APPLICATION NO.	FILING DATE	FIRST NAMED INVENTOR	ATTORNEY DOCKET NO.	CONFIRMATION NO.
10/564,566	01/13/2006	Michael Daniels	TFEL0001	2026
30438	7590	12/08/2009		
SMYRSKI LAW GROUP, A PROFESSIONAL CORPORATION				
3310 AIRPORT AVENUE, SW				
SANTA MONICA, CA 90405				
EXAMINER				
PATEL, VINOD D				
ART UNIT		PAPER NUMBER		
3742				
MAIL DATE		DELIVERY MODE		
12/08/2009		PAPER

### Office Action Summary

***Arguments/Amendments***

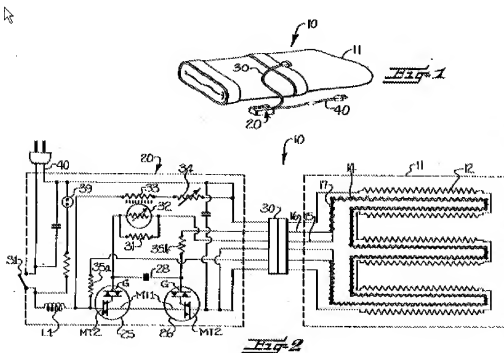
Mills discloses a heating cable (Figure 2, column 3-4) comprising a first conductor (14) comprising a pair of conductors (15,16) which extends along the length of the cable; a second conductor (12) which extends along the length of the cable; a

separation layer (17) which extends along the length of the cable and is interposed between the pair of conductors (15, 16), an outer insulating jacket (column 4, line 9, US 3222497) extending along the length of the cable and around the first and second conductors and the separation layer wherein the first and second conductors are connected at a first end of the cable in series such that current can flow in both directions through the first and second conductors, the first and second conductors are connected at a second end of the cable to an AC power supply equal currents flow in opposite directions through adjacent portions of the first and second conductors, and wherein the separation layer is formed such that the separation layer has a negative temperature characteristic, and the first conductor is formed such that the first conductor has a positive temperature characteristic (column 6, line 51-51) reduces with increasing temperatures. Mills discloses a heating cable (Figure 3) comprising a first conductor (14') which extends along the length of the cable; a second conductor (12) which extends along the length of the cable; and an outer insulating jacket (column 4, line 9, US 3222497) extending along the length of the cable and around the first and second conductors wherein the first and second conductors are connected at one end of the cable in series such that current can flow in both directions through the conductors, the first and second conductors are connected at the other end of the cable to respective poles of an AC power supply equal currents flow in opposite directions through adjacent portions of the conductors, and the first conductor is formed such that it has a positive temperature characteristic (column 6, lines 40-55).

Mills does disclose a separation layer in Figure 2 which extends along the length of the cable and is interposed between the first and second conductors; the separation layer has a negative temperature characteristic.

**Fig. 3**

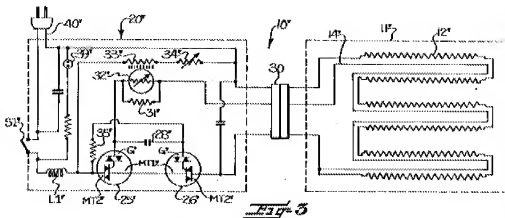
Mills does not disclose a separation layer in Figure 3 which extends along the length of the cable and is interposed between the first and second conductors; the separation layer has a negative temperature characteristic.

Applicant's arguments with respect to claims have been fully considered but they are not persuasive. Mills discloses in Figures 2 & 3, "when the first and second conductors are connected at a second end of the cable to an AC power equal flow in opposite directions through adjacent portions of the first and second conductors." With respect to separation layer having negative temperature coefficient, Sopory clearly teaches use of separation layer having negative temperature coefficient. Mills discloses a heater cable as shown in Figures 2 and 3 to generate heat using AC current, equal current flows in opposite direction. The combination of prior art is proper because, (a) Combining prior art elements according to known methods to yield predictable results; (b) Simple substitution of one known element for another to obtain predictable results; (c) Use of known technique to improve similar devices (methods, or products) in the same way; (d) Applying a known technique to a known device (method, or product) ready for improvement to yield predictable results; (e) " Obvious to try " – choosing from a finite number of identified, predictable solutions, with a reasonable expectation of success; (f) Known work in one field of endeavor may prompt variations of it for use in either the same field or a different one based on design incentives or other market forces if the variations are predictable to one of ordinary skill in the art; (g) Some

FIGURE 4

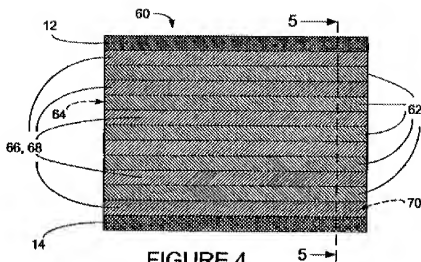
Sopory teaches (column 2, lines 39-52, Figure 4) use of PTC and NTC or ZTC and/or VSM material for use in protection of electrical circuits.
